## **Planning and Zoning Board Agenda November 12, 2019**

### **Planning and Zoning Board At 6:00 PM**

- C. Site Plan - Kolomyiko: A request by Craig Hedgecock, P.E., P.S.M., applicant and agent for Ivan and Galina Kolomyiko, property owners, for consideration of a Site Plan to construct a ±5,880 square foot light manufacturing facility, with associated paving, grading, drainage, landscaping and infrastructure improvements, on a ±1.61 acre subject property, located 14000 block of West SR235, south of SR235, east of the intersection of SR235 and CR 241; Tax Parcel Number 03129-001-000 (Quasi-Judicial Hearing).

- D. Site Plan – Alachua Retail Center: A request by Robert Walpole, P.E., of Causseaux, Hewett, & Walpole, Inc., applicant and agent for Om Namah Shivaay, LLC, property owner, for consideration of a Site Plan to construct a ±8,400 square foot commercial building with site improvements, on a ±1.24 acre subject property, located at 15405 NW US Highway 441 and at 15419 NW US Highway 441; Consisting of Tax Parcel Numbers 03583-000-000 and 03583-001-000; FLUM: Commercial; Zoning: Commercial Intensive (CI).

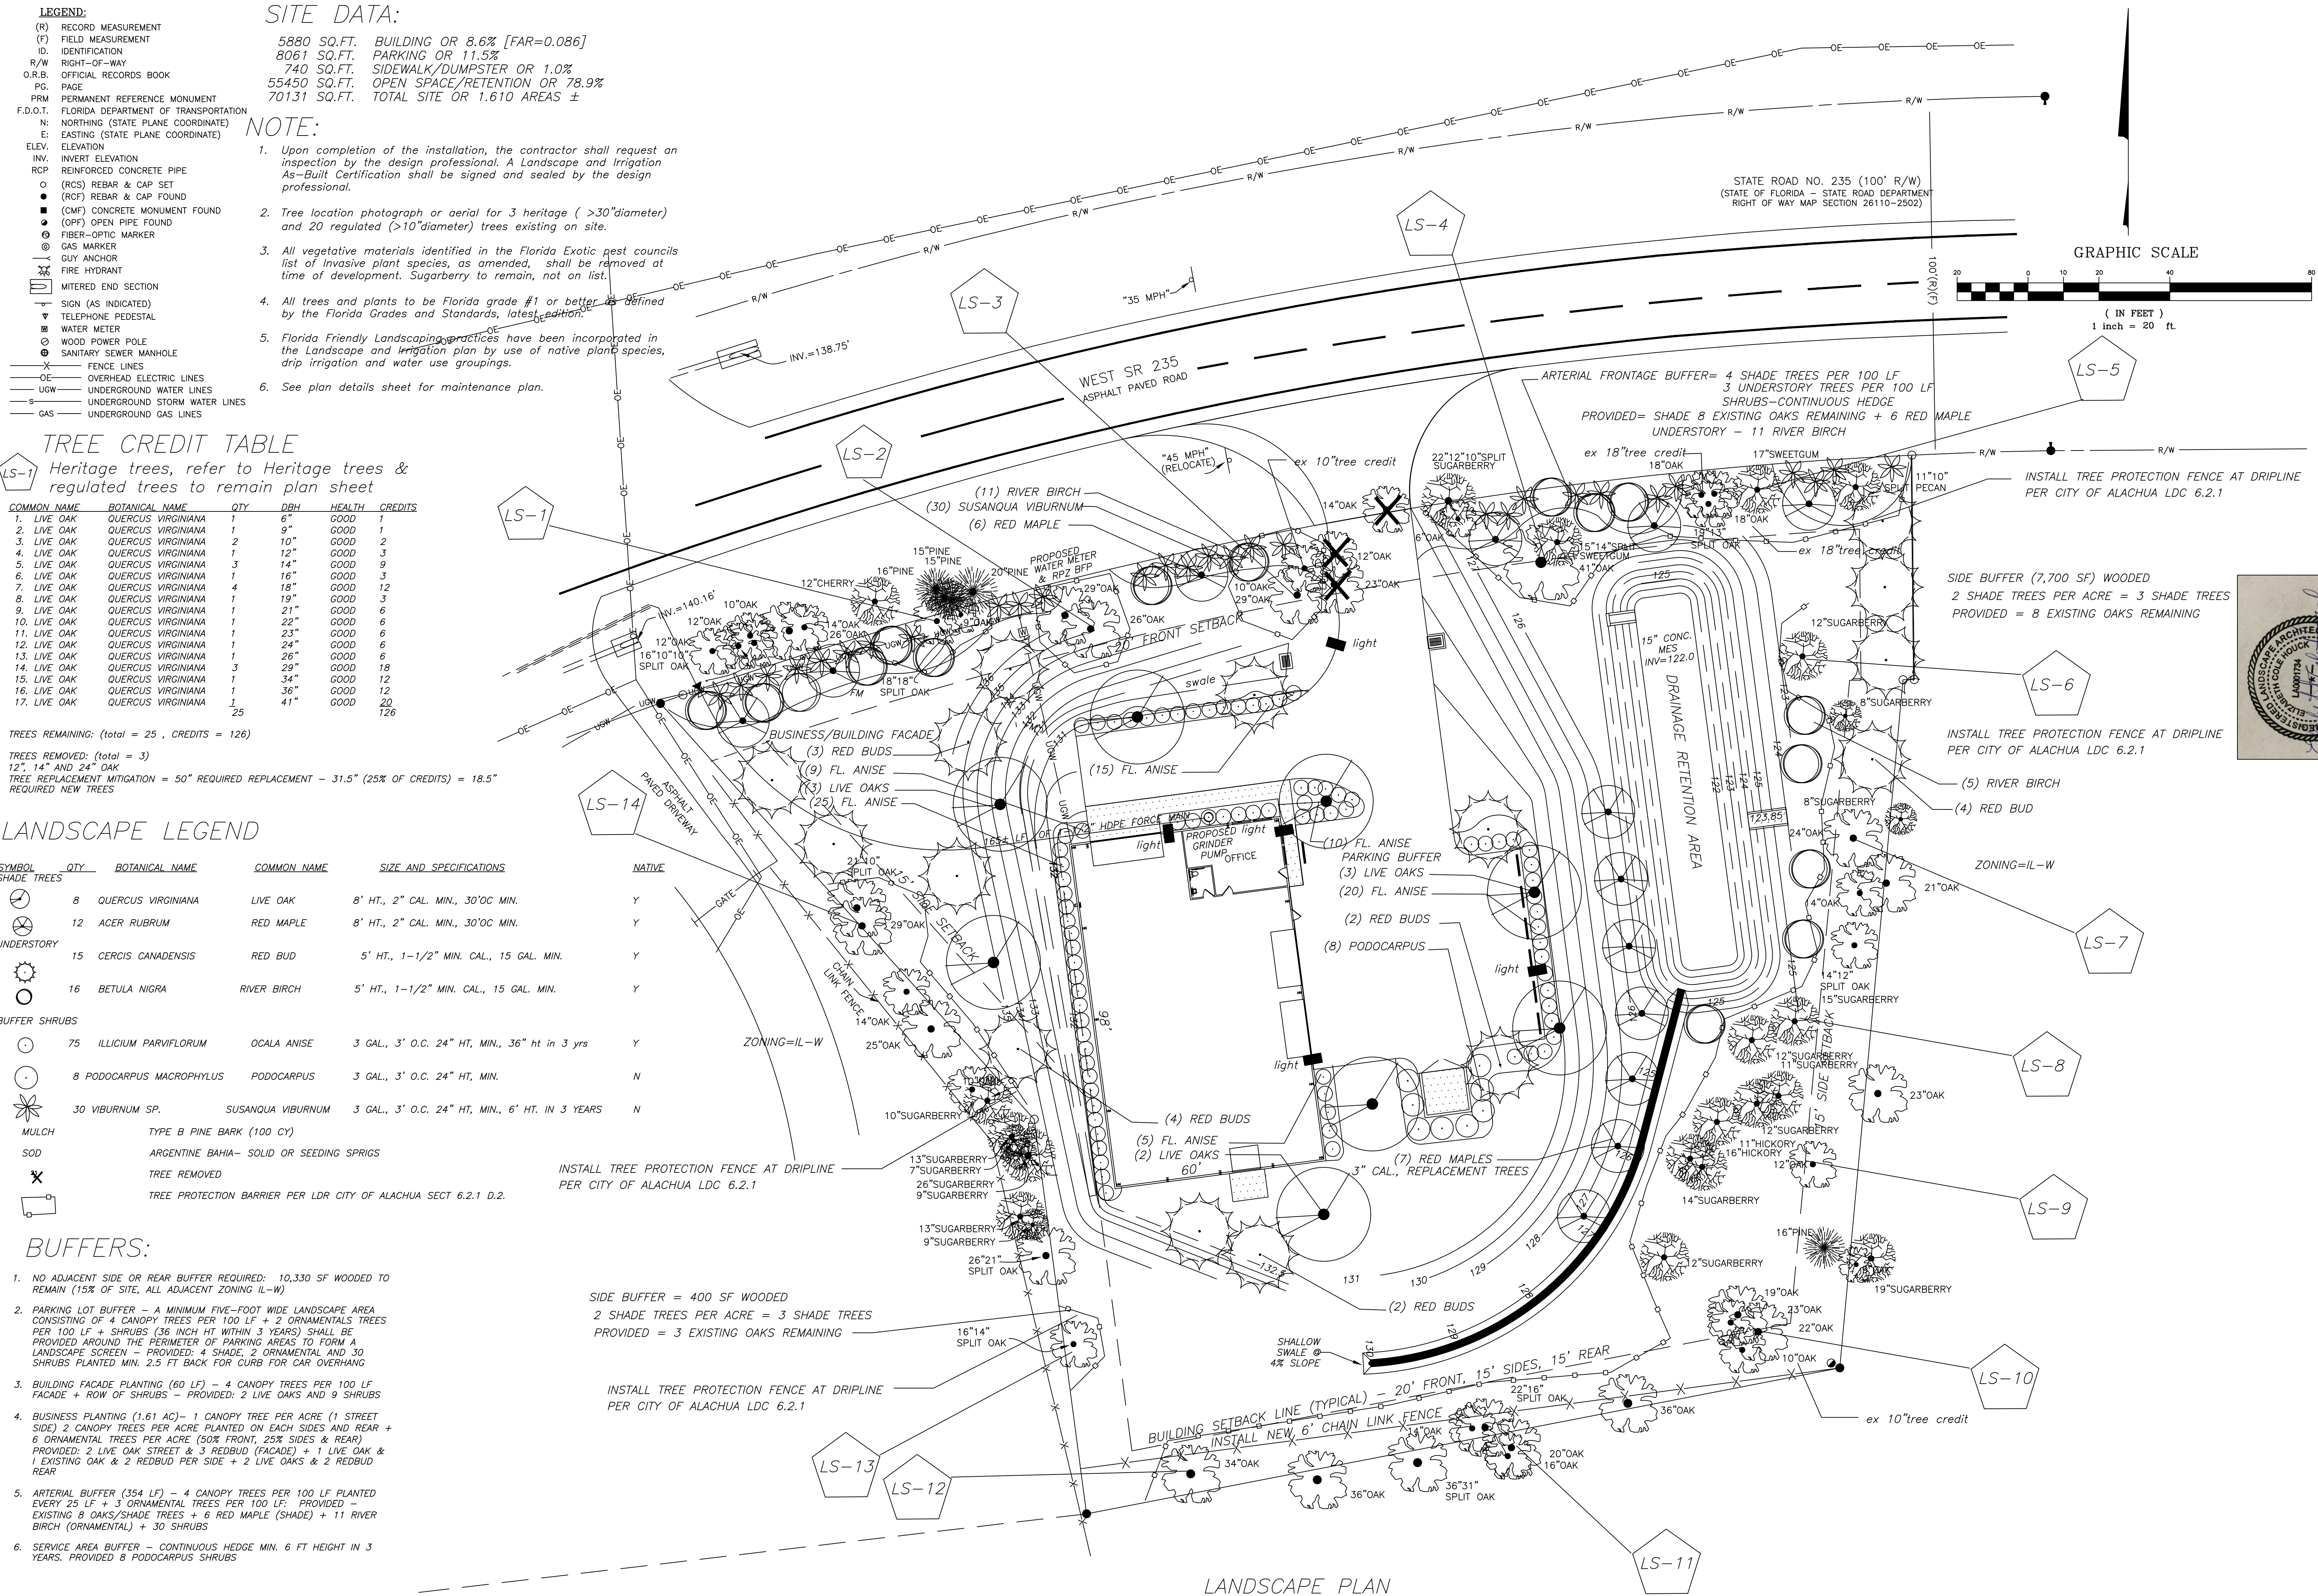
- d. Three trees used for tree credit not identified on plan (2 18” oaks, & 1 10” oak).
  - e. As shown on Sheet 7 of 10, three oaks are proposed to be removed (12”, 14”, and 23” oak). Per Section 6.2.1 (D) (1), new trees must be installed to replace trees. Up to 25% of the tree credits can be used to meet the mitigation requirement. Trees located off the subject property cannot be counted towards tree credits.

- f. On Sheet 6 of 10, an additional tree is shown to be removed in approximate location of proposed storm water inlet. This tree is not identified on Sheet 7. Please address.

- g. Note 2 on landscape plan (Sheet 7 of 10) states no champion, heritage, or regulated trees exist on site. Please correct.
  - h. Per Section 6.2.2 (D)(1)(d)(iii), a row of shrubs is required along western building façade.

FL PE No. 58206  
SHEET NO. **C1.10**

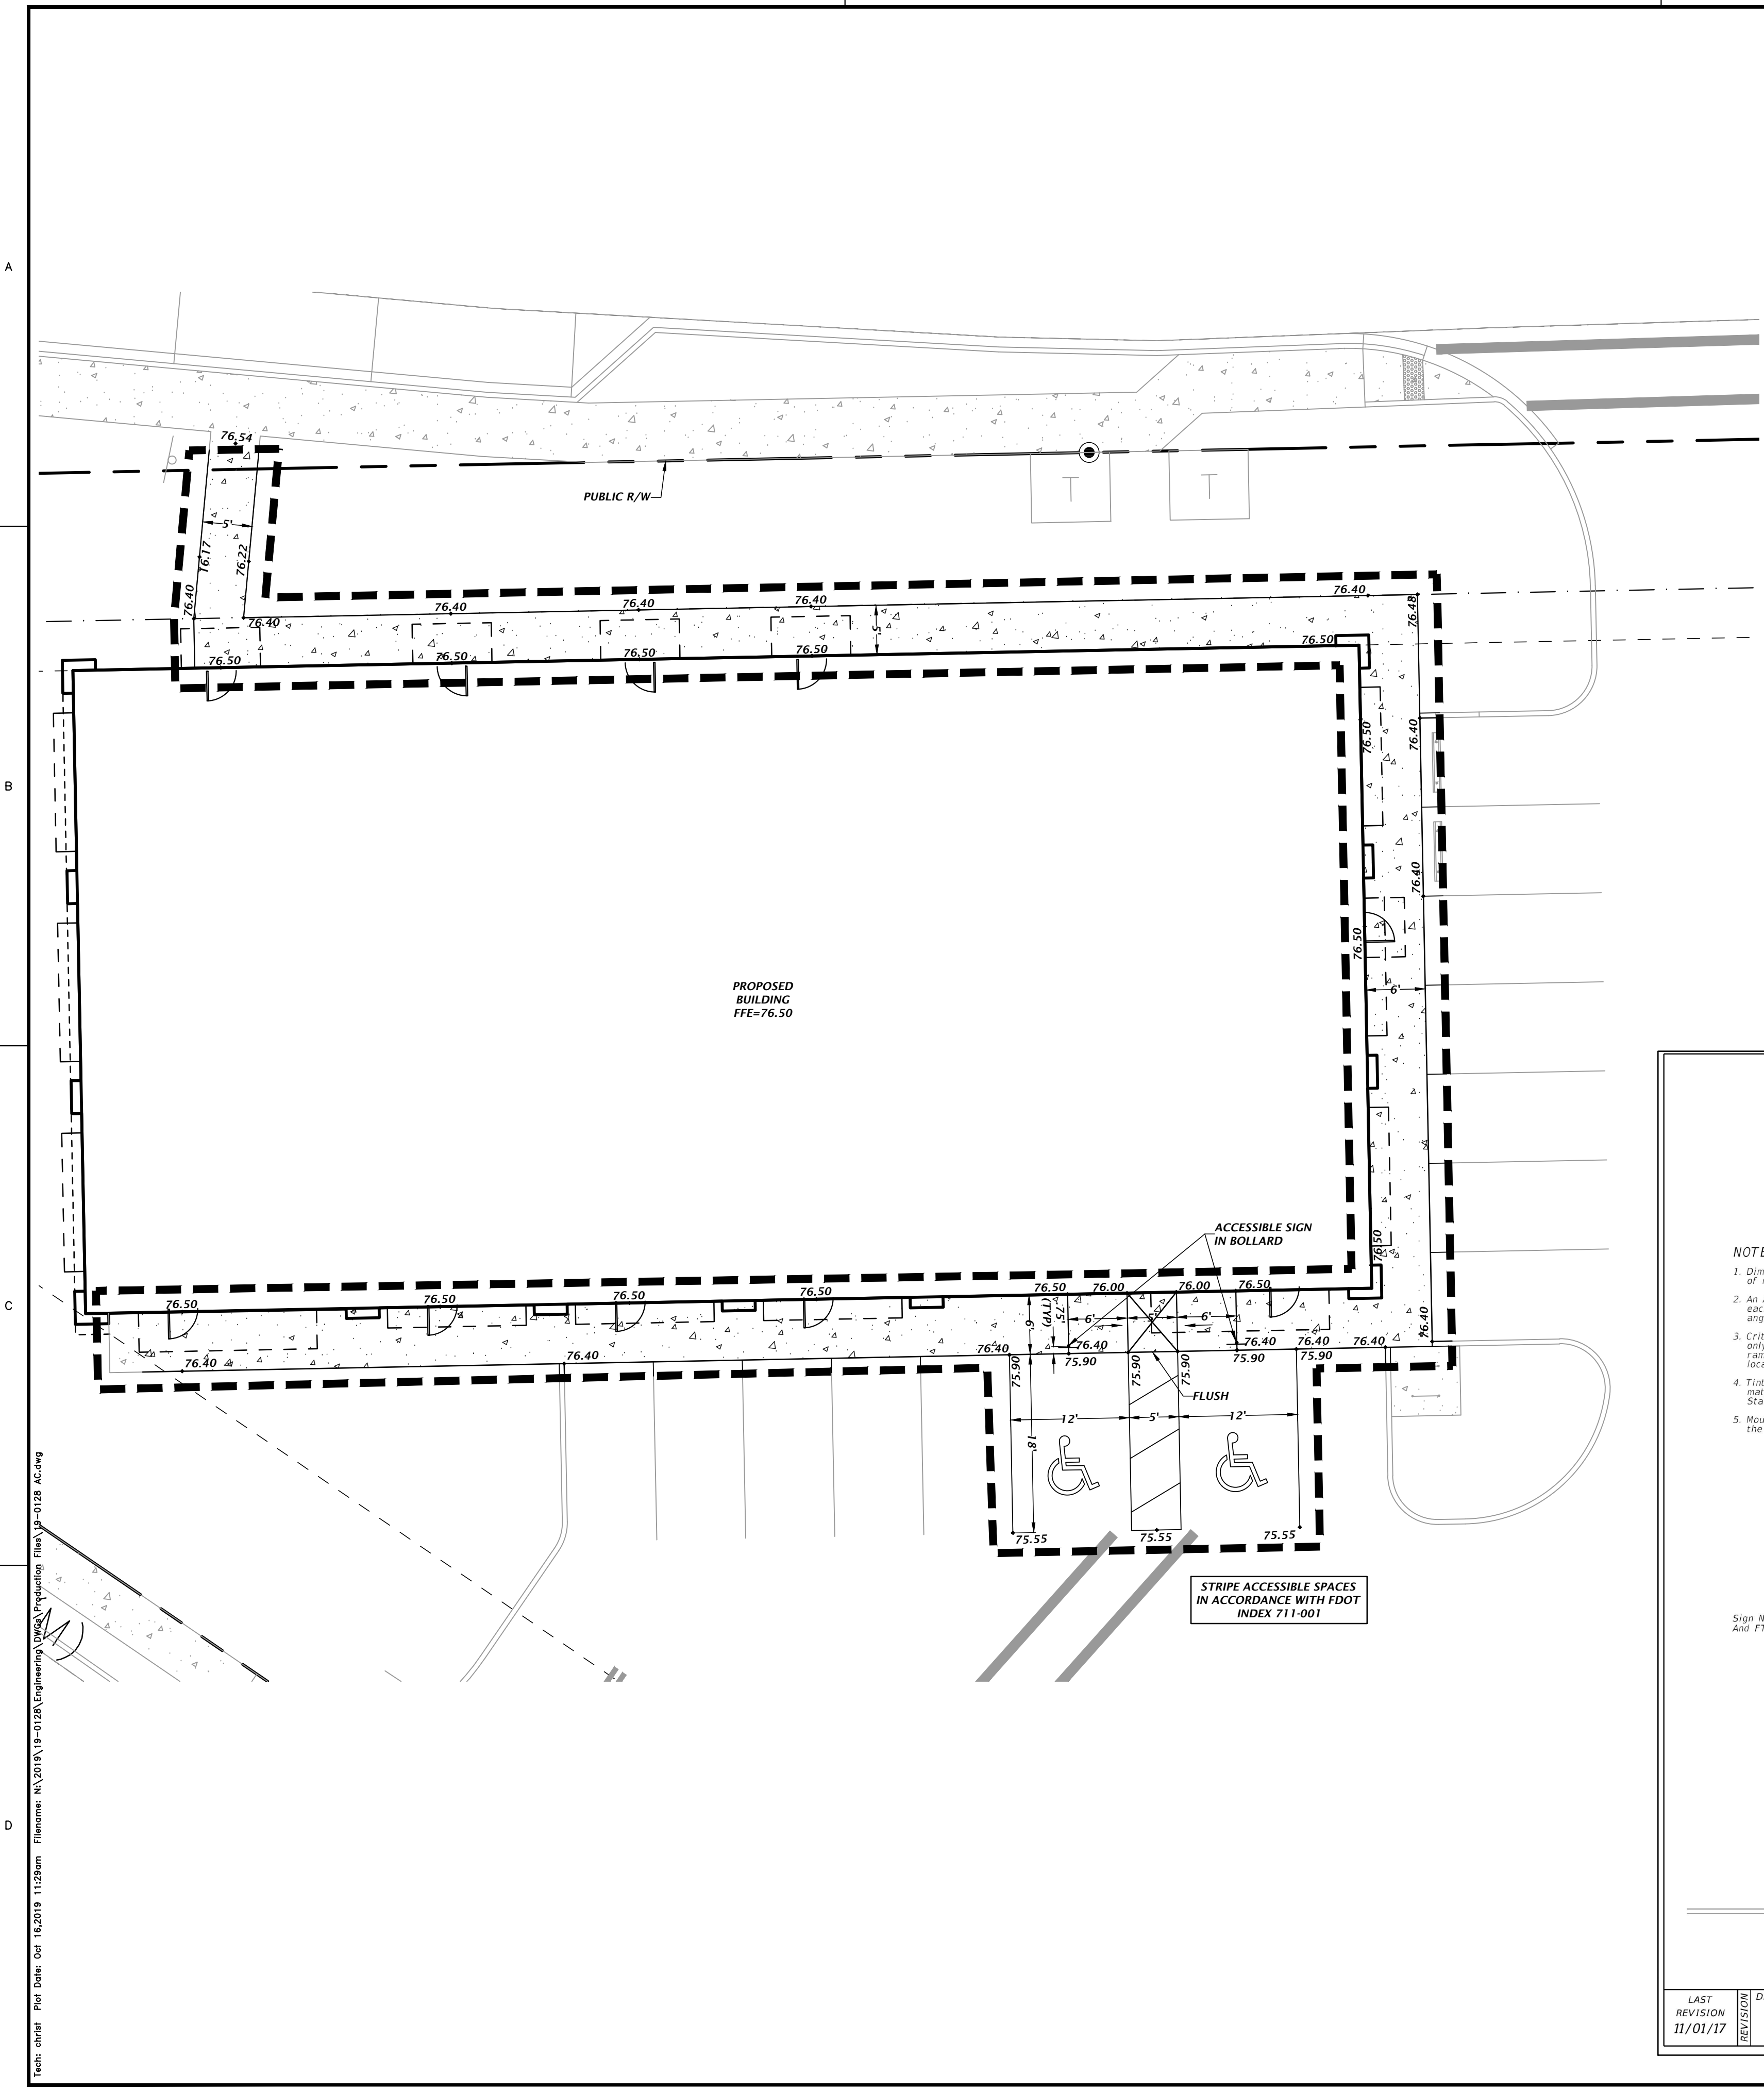
1. The limits of Pod 1 and Pod 2 do not appear to have been updated as it shows on Sheet C1.10.
2. Will there be some kind of construction fencing put up to separate Pod 1 and Pod 2 during construction?
